REPORT TO PLANNING COMMISSION

Hearing Date: February 6, 2012

FILE #: 2011-7854
Applicant/Owner: Shen Design/Garland Chan
Location: 1363 Norman Drive (APN: 313-12-008)
Proposed Project: Design Review for a new 3,783 square foot two-story home and a new 699 square foot single-story accessory living unit resulting in approximately 48% Floor Area Ratio.

SITE PLAN

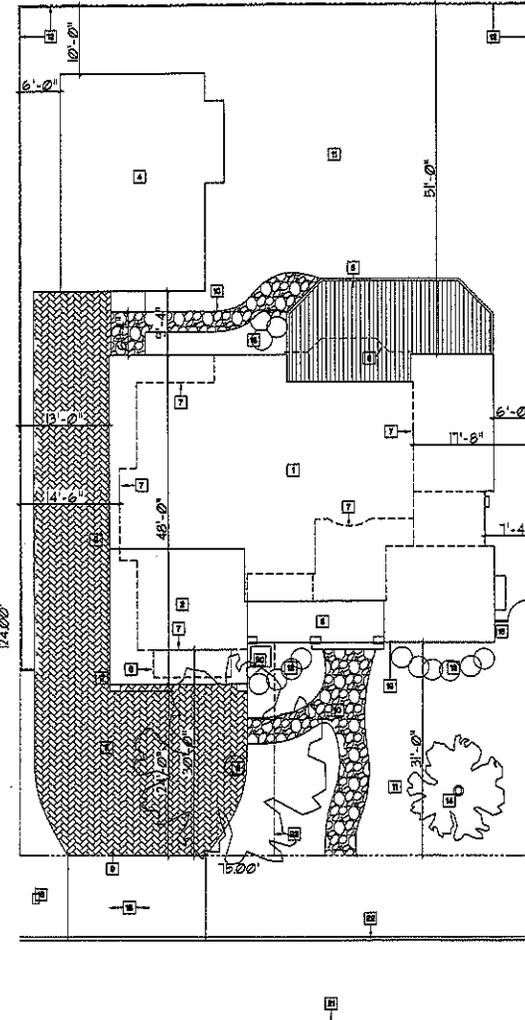
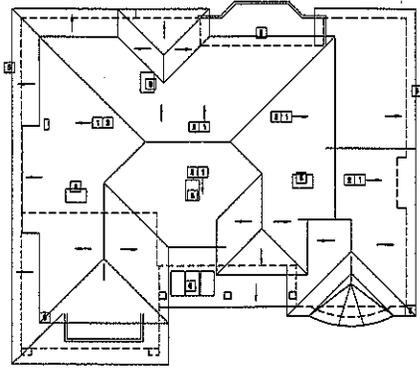
The project as proposed does not comply with the minimum second story side setback along the right side elevation. An interior staircase is provided along the right side of the home; this staircase includes a landing approximately seven feet above the ground floor which constitutes a second floor. The minimum side setback for a second story element is nine feet; the second story area of the staircase area is located at a setback of 7 feet 4 inches. Staff recommends Condition of Approval PS-1.d requiring the applicant to increase the right side setback in this area to at least 9 feet.

The project proposes to remove a large mature Sycamore tree located along the property frontage. The tree is in good condition and the City Arborist recommends preservation. The applicant does not wish to preserve the tree, as it is located in the proposed driveway area (see Sheet A-1.2 of the project plans) and currently obstructs access to the garage. However, staff finds there are design alternatives to preserve the tree. The house could be relocated closer to the left side property line while still meeting setback requirements. This would shift the garage and eliminate the conflict with the tree. The driveway leading back to the accessory living unit would need to be eliminated, but there would be still be sufficient space for the required three uncovered parking spaces along the property frontage. Alternatively, the orientation of the home could be reversed to place the garage on the right side of the property. This orientation would be less compatible with the Single Family Home Design Techniques, which state that a new two-story home is encouraged to place its lower single-story elements on the side adjacent to a single-story neighbor. However, this option is feasible if maintaining a driveway to the rear accessory living unit is found to be desirable. Staff recommends Condition of Approval PS-1.f requiring design modifications to preserve the existing tree by shifting the home toward the left side property line. This modification would have the added benefit of addressing the side setback issue noted above regarding the stairwell, and may also improve solar access to the adjacent detached garage.

- d) The project design shall be modified to provide a minimum second story side setback of 9 feet along the right side property line side by relocating the proposed home closer to the left side and/or redesigning the interior staircase area.

- f) The project design shall be modified to preserve the existing mature Sycamore tree located along the property frontage. Modifications shall include shifting the home closer to the left side

property line to relocate the garage, eliminating the driveway along the side property line serving the accessory living unit, and relocating the accessory living unit's required uncovered parking space to front setback area along the left side of the property. [COA] [PLANNING]

SHEET TITLE:
FRONT ELEVATION
REAR ELEVATION

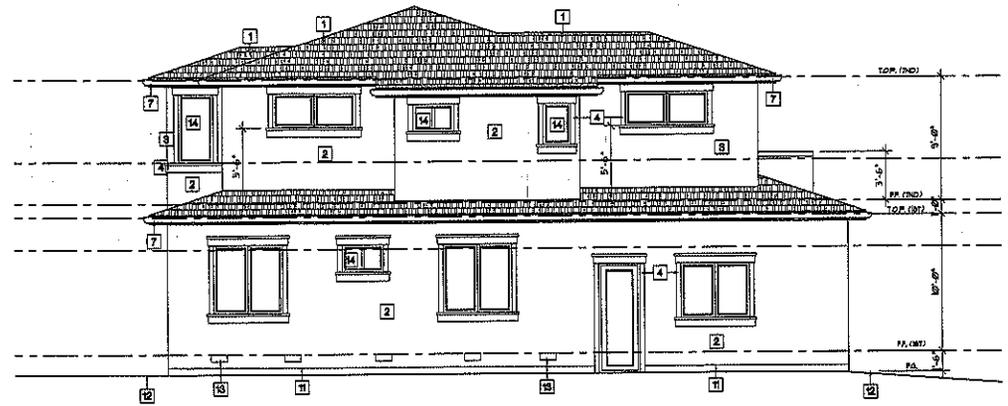
Staff remains concerned about the height of the curved tower element located on the right side of the front facade. Although proposed as a single-story area, this element has an interior height of 14 feet from floor ceiling, and a total height of 19'2" from grade to top of roof. Staff finds a plate height of 14 feet to be excessive in the context of this neighborhood. Plate heights for surrounding single-story homes are generally eight feet. Newer homes often use plate heights of nine to 10 feet to provide the opportunity for high ceilings. In this case the tower element is placed adjacent to an existing single-story home with eight-foot plates, exacerbating its visual impact. Staff finds this significant height difference to be inconsistent with the Single Family Home Design Techniques and recommends Condition of Approval Ps-1.a requiring the plate height of this feature be reduced to no more than 10 feet (Attachment B). The property owner is not in agreement with staff's recommendation as he desires a very tall ceiling for the home's formal living room. The applicant also notes that the proposed height of this element balances the overall house design by falling midway between the first and second story levels.

- a) The plate height of the curved tower element located on the right side of the front facade shall be reduced to no more than 10 feet.
 - b) The window at the landing of the interior staircase along the right side elevation shall be modified to reduce privacy impacts by increasing the sill height to at least 5 feet as measured from the landing and/or by using translucent glazing.

RIGHT ELEVATION

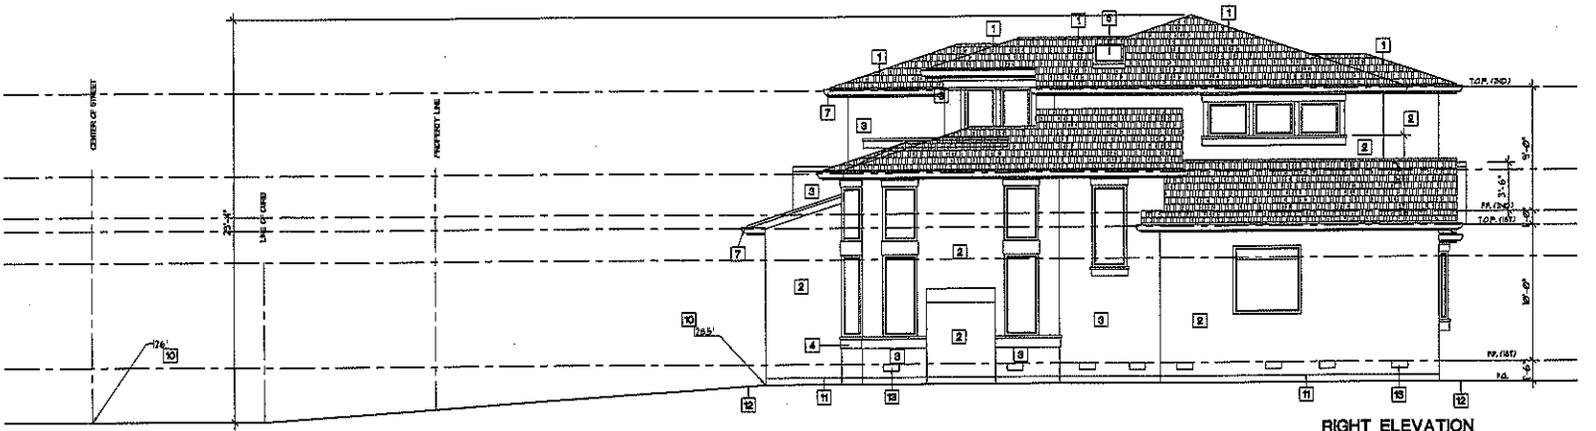
The proposed two-story structure includes windows on both sides of the second floor. Most of these side windows are proposed with high sills (five feet or more above the floor). Those with lower sills use translucent glazing to reduce privacy impacts. However, staff is concerned about potential privacy impacts resulting from a window along the right side elevation at the interior staircase. The staircase includes a landing approximately seven feet above the ground

floor which is directly adjacent to a large side window overlooking the adjacent single-story home. In addition, staff is concerned about privacy impacts resulting from a large low-sill window on the rear elevation in the tub area of Master Bathroom #1. To address these potential privacy impacts, staff recommends these windows be redesigned incorporate high sills or use translucent glazing (Conditions of Approval PS-1.b and PS-1.c).
